Planned Time Sync Comments on SA Ballot

Geoff Garner – Analog Devices (Consultant)

- ❑ However, the latest simulations indicate that some minor changes are required to the specification. These will be proposed via comments on the SA Ballot.
- ❑ This contribution documents the expected changes.

Annex D - (Informative) Time Sync

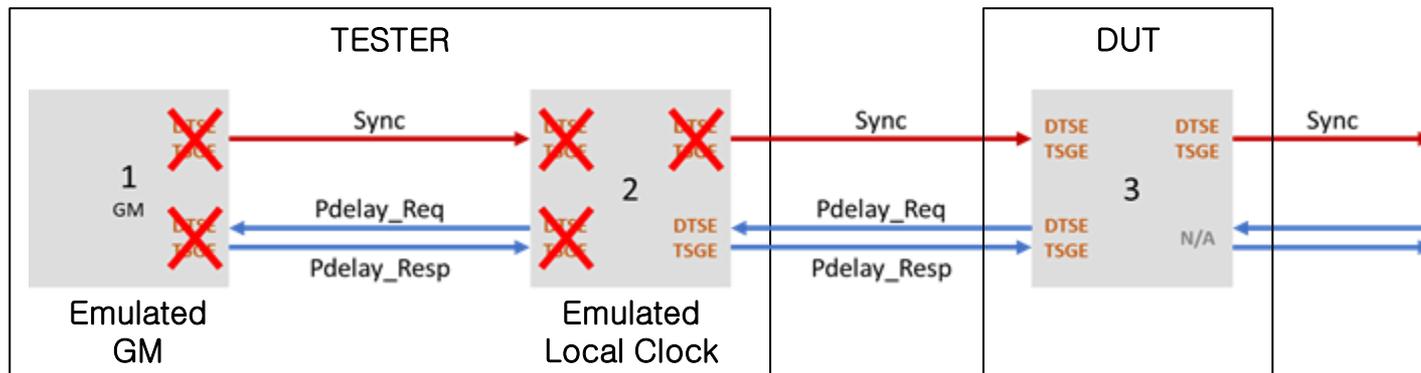
- ❑ Add explanation for the asymmetric dTE normative requirements in Table 14
- ❑ Add explanation of the meanLinkDelay normative requirements in D.3.4, D.3.5 and D.3.6
- ❑ Add description of potential test for meanLinkDelay to D.4
 - In particular, where the test equipment should simulate TSGE and DTSE...

- ...i.e. only at the TX and RX ports to the DUT and only for Pdelay_Req and Pdelay_Resp messages.
